# Access Compliance Report

## Public Rights-of-Way

### (Curb Ramps)

Intersection ID: 23944	Main Street: BOSHAM_LN	Cross Street: PRESCOTT_POND_LN	Location: N
ADA ID: 719E9A924922	Ramp Type: Perp	Initial Pass/Fail: Fail	Overall Compliance: No
Severity Score: 21.25			
Codes/Mitigation Info/Possible Solution		Field Measurements/Component Compliance

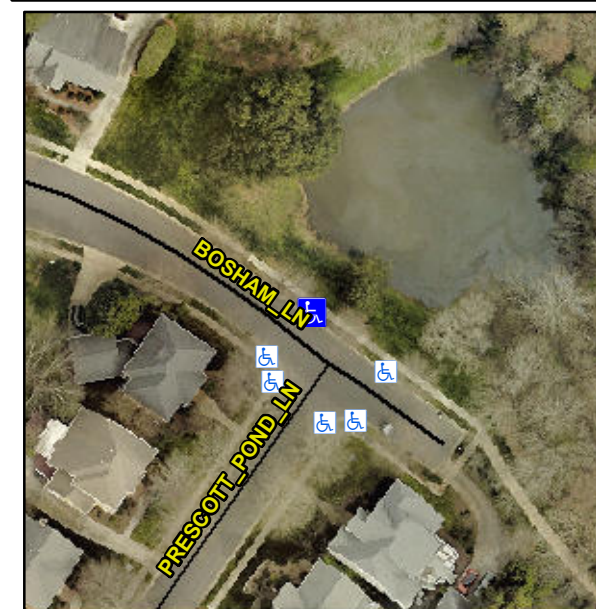
**Not Found, R304.5.1, R304.2.2**

Compliance	Description	Data	Compliance	Description	Data
N/A	Ramp Length (in)	47.0	No	Ramp Slope (%)	8.4
No	Ramp Width (in)	47.0	Yes	Ramp XSlope (%)	1.4
N/A	Flare Type LT	N/A	N/A	Flare Type RT	N/A
N/A	Flare Slope LT (%)	N/A	N/A	Flare Slope RT (%)	N/A
N/A	Flare Traversable LT?	N/A	N/A	Flare Traversable RT?	N/A
N/A	Landing Length (in)	N/A	N/A	DWS Provided?	N/A
N/A	Landing Width (in)	N/A	N/A	DWS Contrast?	N/A
N/A	Landing Slope (%)	N/A	N/A	DWS Length (in)	N/A
N/A	Landing X Slope (%)	N/A	N/A	DWS Full Width?	N/A
N/A	Landing Curb? (Y/N)	N/A	N/A	DWS Offset (in)	N/A
N/A	Shared Landing?	N/A			
N/A	Gutter Ponding?	N/A	N/A	Gutter Slope (%)	N/A
N/A	Gutter Lip Ht (in)	N/A	N/A	Gutter X Slope (%)	N/A
N/A	Painted X Walk1?	No	N/A	Painted X Walk2?	N/A
	X Walk 1 Direction	To SW		X Walk 2 Direction	N/A
N/A	X Walk 1 Width (in)	N/A	N/A	X Walk 2 Width (in)	N/A
	X Walk 1 Slope (%)	3.3		X Walk 2 Slope (%)	N/A
	X Walk 1 X Slope (%)	1.0		X Walk 2 X Slope (%)	N/A

**Remove & Replace Entire Ramp.**
